CITY OF OPELIKA
HISTORIC PRESERVATION COMMISSION
May 11, 2023
4:30 p.m.
Meeting Chambers at Opelika Municipal Courtroom
300 MLK Boulevard

City of Opelika
Historic Preservation Commission
Staff Report

Agenda Item #: 1
Meeting Date: 5/11/23
Action Requested: COA: Install Window
Location of Property: 503 S. 8th St; Geneva Historic District
Petitioner: Michael Peterson

Agenda Item #: 2
Meeting Date: 05/11/2023
Action Requested: COA: Remove Doors and Install Window; Add Porch Railings
Location of Property: 1100 3rd Ave; Northside Historic District
Petitioner: Michelle Johnson

Diagram with new window in place

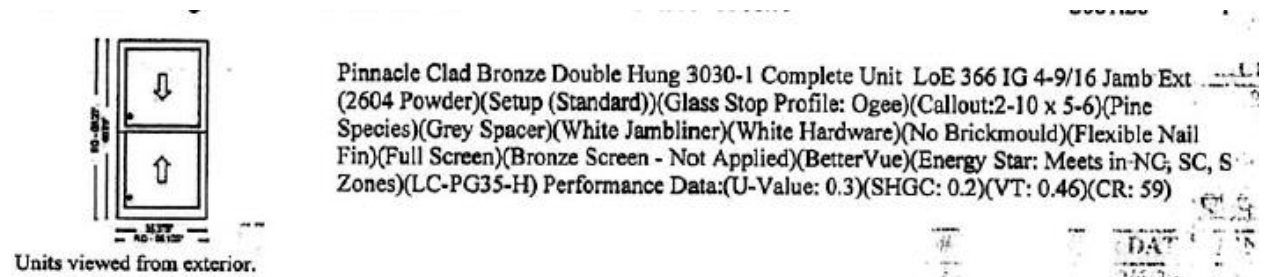
1. Install window on second floor above garage facing side of house toward the rear of structure. The window is identical to windows installed by contractor; Windsor Pinnacle wood clad bronze double hung. The finished window upon completion will appear to have always been there. The trim style and paint colors will match the original construction.

1. Staff recommends approval of installation of new wood clad window to match existing windows.
